## PCI-SIG ENGINEERING CHANGE NOTICE

<b>TITLE:</b>	Vendor-Specific Extended Capability (VSEC)
<b>DATE:</b>	January 7, 2004
<b>AFFECTED DOCUMENT:</b>	PCI Express Base Specification 1.0a
<b>SPONSOR:</b>	Joe Cowan; Hewlett-Packard Company

**Figure 7-y1: PCI Express VSEC Structure**

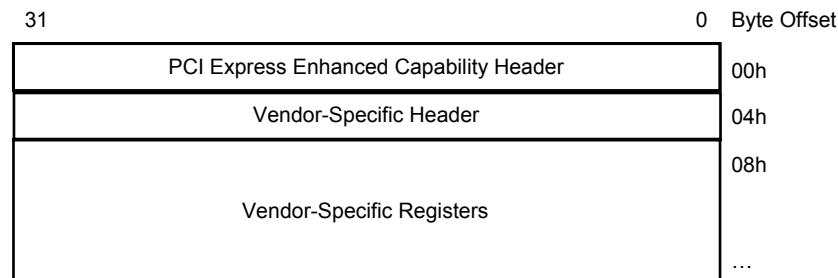
Figure 7-y1 details allocation of register fields in the VSEC structure. The structure of the PCI Express Enhanced Capability Header and the Vendor-Specific Header is architected by this specification.

With a PCI Express Function, the structure and definition of the Vendor-Specific Registers area is determined by the vendor indicated by the Vendor ID register located at byte offset 00h in PCI-compatible Configuration Space. With an RCRB, a VSEC is permitted only if the RCRB also contains an RCRB Header Capability structure, which contains a Vendor ID register indicating the vendor.
